Access Compliance Report

Public Rights-of-Way

(Curb Ramps)

Intersection ID: 19674	Main Street: BARCLAY_DOWNS_DR	Cross Street: MORRISON_BV	Location: NE
ADA ID: 7795AAE841EE	Ramp Type: Perp	Initial Pass/Fail: Fail	Overall Compliance: No
Severity Score: 25			
Codes/Mitigation Info/Possible Solution		Field Measurements/Component Compliance

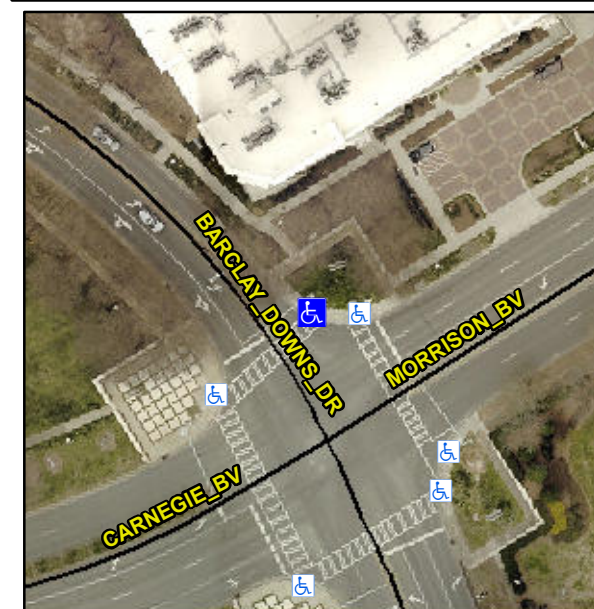
Not Found, R304.2.2, R304.5.3

Compliance	Description	Data	Compliance	Description	Data
N/A	Ramp Length (in)	35.0	No	Ramp Slope (%)	10.0
Yes	Ramp Width (in)	48.0	No	Ramp XSlope (%)	5.4
N/A	Flare Type LT	N/A	N/A	Flare Type RT	N/A
N/A	Flare Slope LT (%)	N/A	N/A	Flare Slope RT (%)	N/A
N/A	Flare Traversable LT?	N/A	N/A	Flare Traversable RT?	N/A
N/A	Landing Length (in)	N/A	N/A	DWS Provided?	N/A
N/A	Landing Width (in)	N/A	N/A	DWS Contrast?	N/A
N/A	Landing Slope (%)	N/A	N/A	DWS Length (in)	N/A
N/A	Landing X Slope (%)	N/A	N/A	DWS Full Width?	N/A
N/A	Landing Curb? (Y/N)	N/A	N/A	DWS Offset (in)	N/A
N/A	Shared Landing?	N/A			
N/A	Gutter Ponding?	N/A	N/A	Gutter Slope (%)	N/A
N/A	Gutter Lip Ht (in)	N/A	N/A	Gutter X Slope (%)	N/A
N/A	Painted X Walk1?	Yes	N/A	Painted X Walk2?	N/A
	X Walk 1 Direction	To SW		X Walk 2 Direction	N/A
N/A	X Walk 1 Width (in)	105.0	N/A	X Walk 2 Width (in)	N/A
	X Walk 1 Slope (%)	0.3		X Walk 2 Slope (%)	N/A
	X Walk 1 X Slope (%)	4.1		X Walk 2 X Slope (%)	N/A

Remove & Replace Entire Ramp.
